Agenda for Planning Committee Tuesday, 30th January, 2024, 10.00 am

Reference 23/0571/MFUL

Proposal Redevelopment of site to provide: a) Care home building (Class C2) with associated parking, landscaping, staff and resident facilities and associated works, b) Extra care apartment building (53 units) with associated communal lounge, wellbeing suite, restaurant and care provision (class C2) c) Retirement living apartment building (33 units) with associated communal lounge d) Erection of 4 houses, and 3 townhouses (Class C3) along with accesses; internal car parking, roads, paths, retaining walls, refuse and landscaping associated with development. Retention/refurbishment of building B, erection of habitat building and sub-stations. (Demolition of buildings other than building B) | Former Council Offices Knowle Sidmouth EX10 8HL

Figure 1 - Indicative alternative open space layout

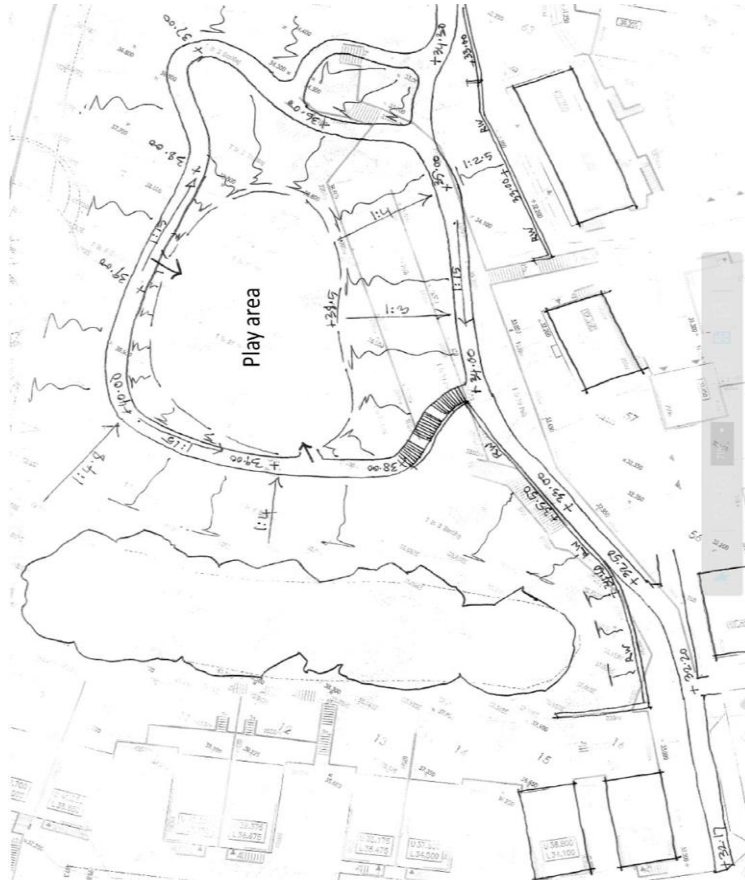
A more naturalistic arrangement designed to a maximum 1:15 path gradient is indicated in figure 1 below, which substantially reduces the height and extent of retaining walls required and provides an un-stepped and more direct pedestrian route connecting from the northern end of the site to the site entrance. Although at a steeper gradient, using tarmac rather than hoggin surfacing as currently proposed would reduce rolling resistance for wheel/ push chair users, countering the increased ramp steepness. It is recommended that the play area and access paths are redesigned along these lines.

The landscape section drawing no. WAIN23460 20A shows retaining walls to the north and south edges of the play area. These are not indicated on the levels plan, dwg. no. 512-P-100, or the Hard Landscape Proposals plans. The drawings should be checked and amended so they correlate.

Figure 1 - Indicative alternative open space layout

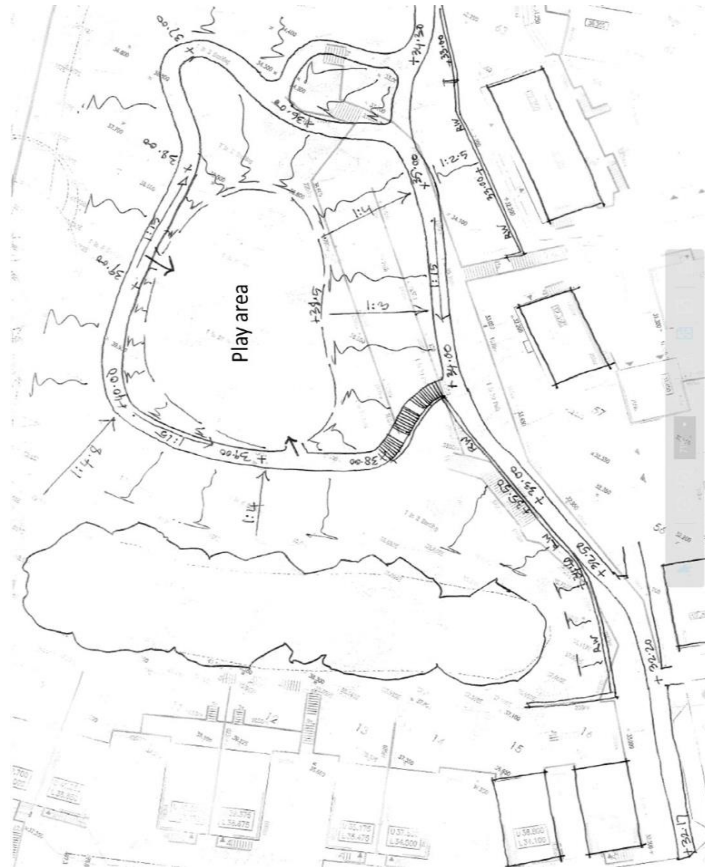
A more naturalistic arrangement designed to a maximum 1:15 path gradient is indicated in figure 1 below, which substantially reduces the height and extent of retaining walls required and provides an un-stepped and more direct pedestrian route connecting from the northern end of the site to the site entrance. Although at a steeper gradient, using tarmac rather than hoggin surfacing as currently proposed would reduce rolling resistance for wheel/ push chair users, countering the increased ramp steepness. It is recommended that the play area and access paths are redesigned along these lines.

It is noted that to the north of plot 16 proposed guard railing for the retaining wall does not follow the line of the wall and should be adjusted so it does.

2.2 Play area (refer layout, hard landscape and enclosure plans)

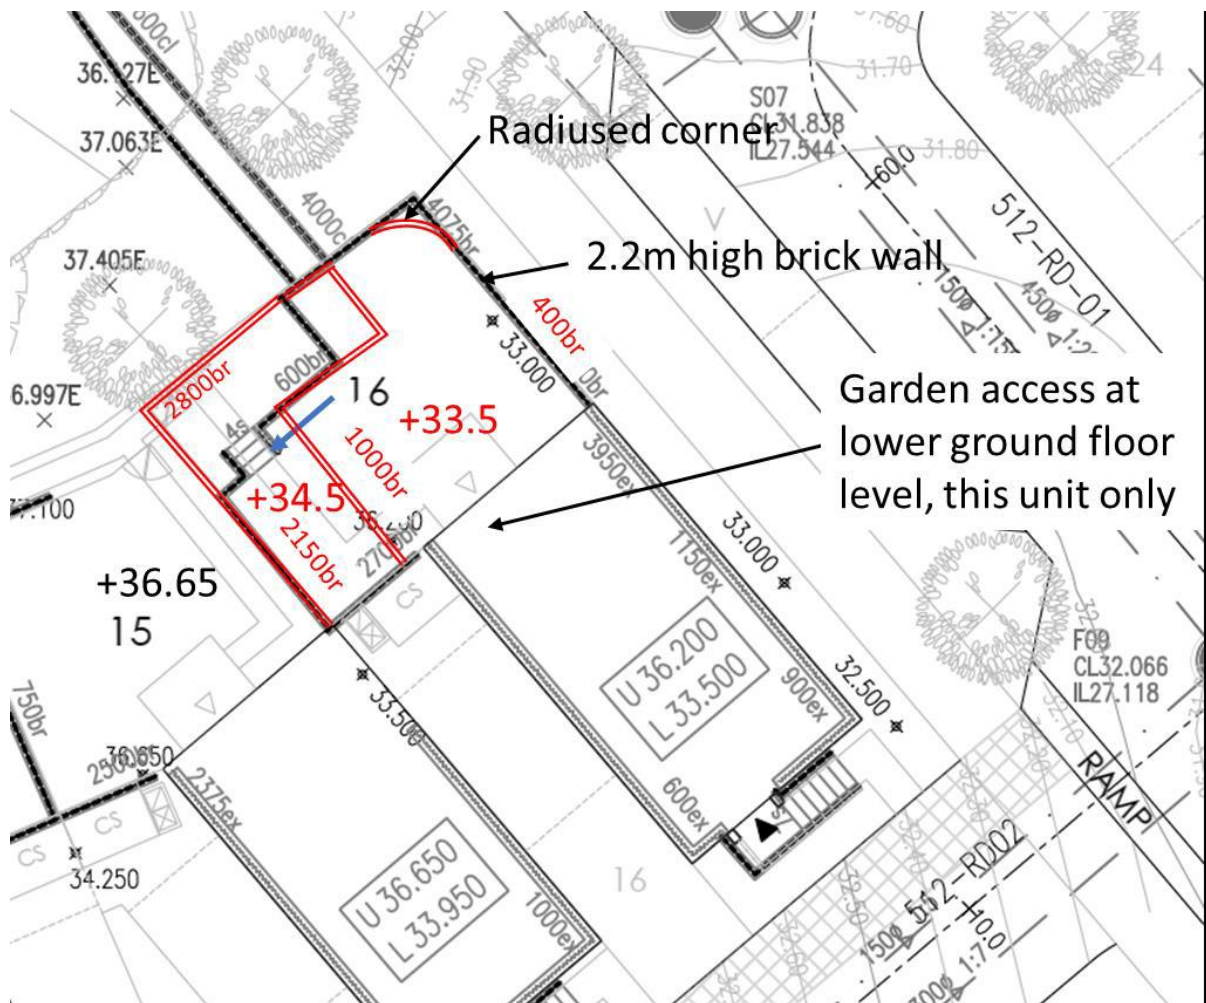
- a) I have previously made suggestions about the proposed access ramp to the play area which I still consider to be an over-engineered solution.
- b) With regard to the play area itself it is understood final design of the play area is subject to local consultation. Notwithstanding this, the bow top railings proposed around the play area seem unnecessary and result in a lot of wasted space on the surrounding banks outside of it. By amending the fencing as per overmarked plan

below the play area can be substantially increased in size allowing free play over the surrounding banks and reducing the amount of fencing significantly.

2.4 Highway design

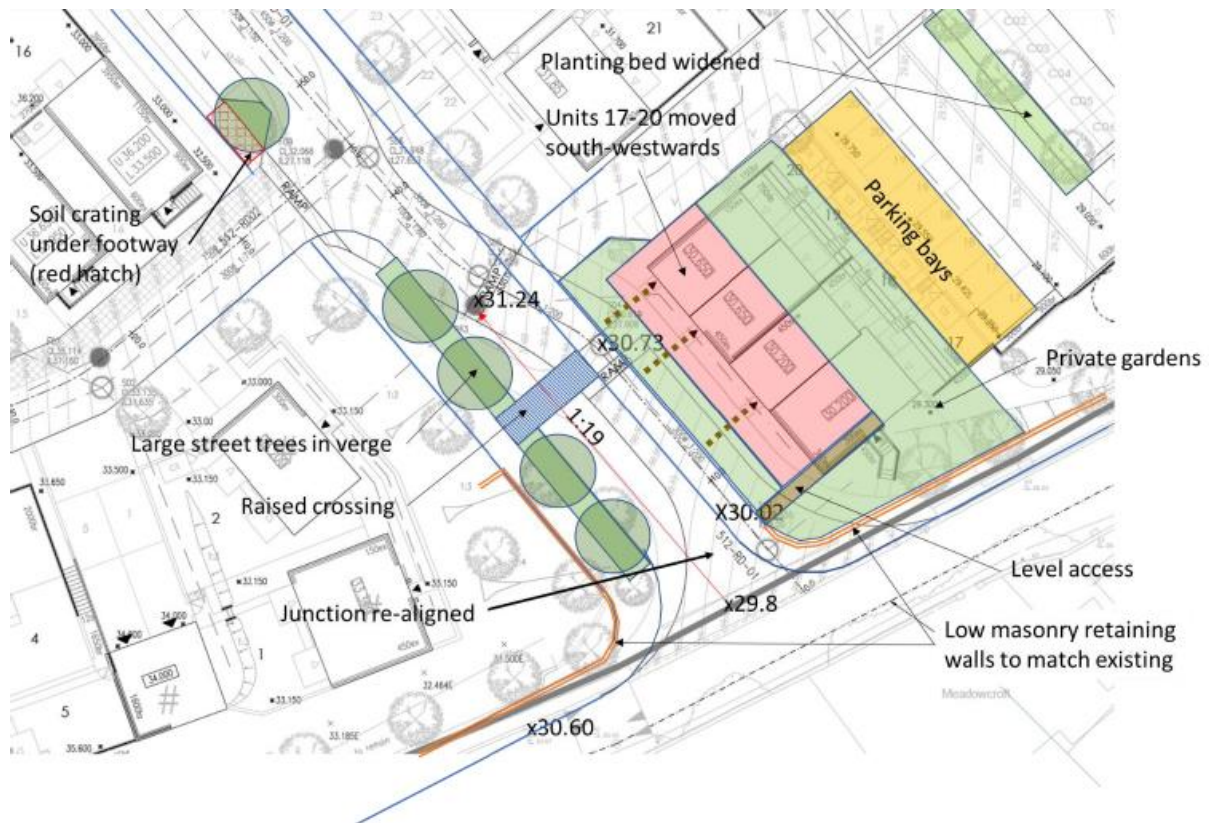
a) At a recent design meeting with the applicant concerns were raised regarding the alignment of the main entrance road and it was understood an alternative layout would be considered moving the entrance slightly westwards along Sidmouth Road. This has not been provided but is considered both feasible and desirable, creating more space within the commercial area courtyard, reducing the openness of the site entrance which is uncharacteristic in the setting of Colyton and reducing the extent of 'left over space' to the west side of the junction (refer overmarked plan extract below).

The junction radii should also be tightened to be more in keeping with Colyton street form and to reduce the crossing distance for pedestrians.

Figure 2. Proposed routes to the play area, with and without steps
Footpath materials and retaining structures

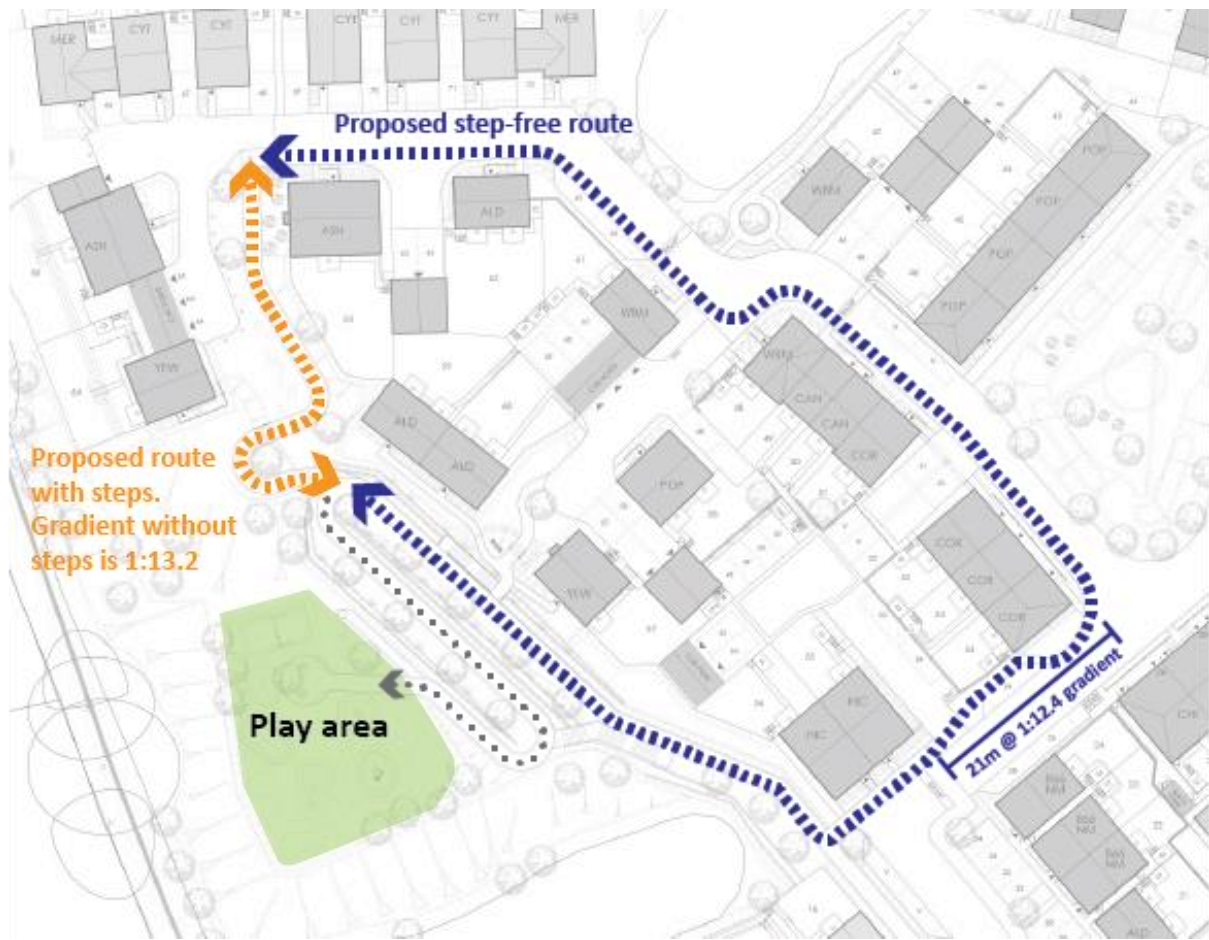
- o The rise of the section with steps from plot 63 to where it joins the main path is 4.3 metres over a distance of 56.9 metres. Without the steps this would give a gradient of 1:13.2.
- o From the start of the path next to plot 63 to the play area entrance is roughly 120 metres. The distance between the same two points but using the road is 305 metres increasing journey distance by 185 metres;
- o The walk along the road to the path next to plot 56 includes a section that rises 2.1 metres over a distance of 26.1 metres giving a gradient of 1:12.4.

People unable to negotiate steps have to use the road to get to the base of the path next to plot 56 for step-free access. The steps are included to avoid a gradient steeper than guidance would suggest but results in a perverse outcome where the journey is longer, and in some parts steeper. The steps are likely to be more of a hazard than a sloping path due to trips and falls. Removing the steps and increasing the length of this section by a small amount to include landings would allow a shorter step-free route with a lower gradient than the current one.
